EX Series Rework Instructions

06/23/2022 rev 0.6

Change Q850 to MMBT3904, and reflash the FW to V2.342.
Kernel version : 1.940

Step5: Replace/Swap Q850

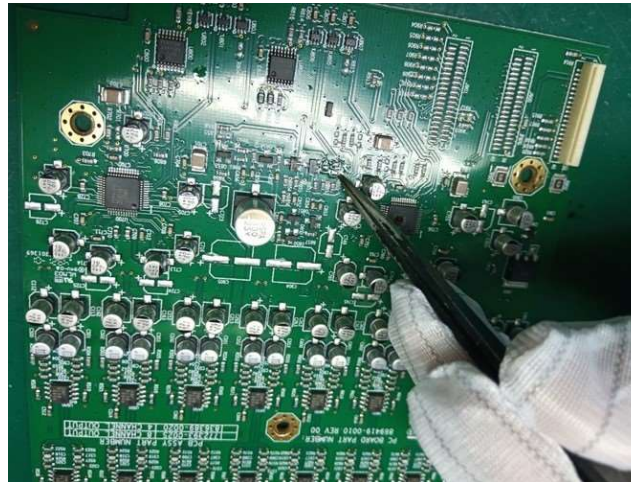
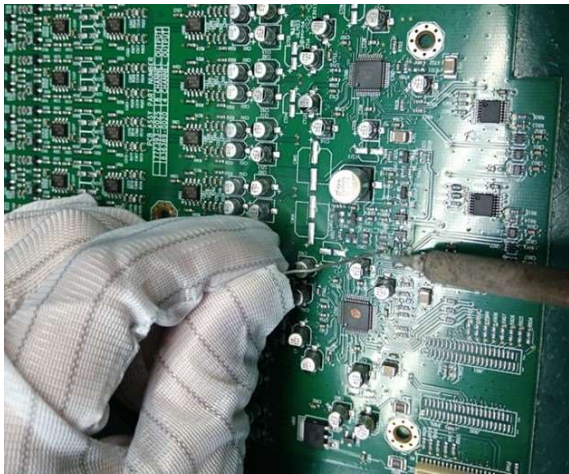
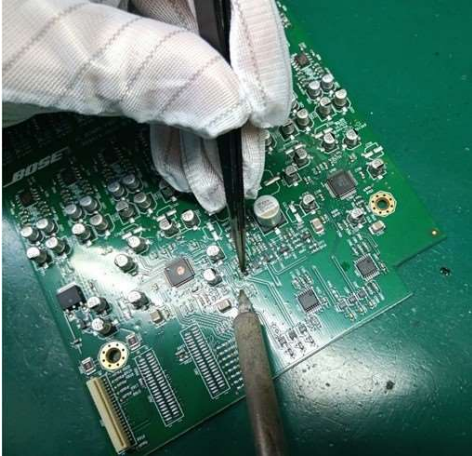
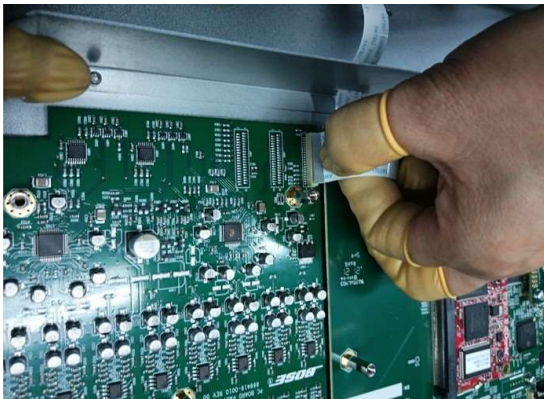
- Step 5: Replace/swap the transistor Q850 with **Bose p/n 146819** (TRANSISTOR,NPN,40V,0.2A,MMBT3904,SOT23) (DIODES INC -- MMBT3904-13-01-F, MMBT3904Q-7-F ; ONSEMI -- MMBT3904LT1G, MMBT390)
Using soldering iron tip to de-solder the Q850 part and then remove it away from the audio output board,
Using a tweeters to place a new SOT-23 MMBT3904 part on board. Make sure that the part is placed pin to pin and then solder its pins
Cleaning the solder joints with a brusher.
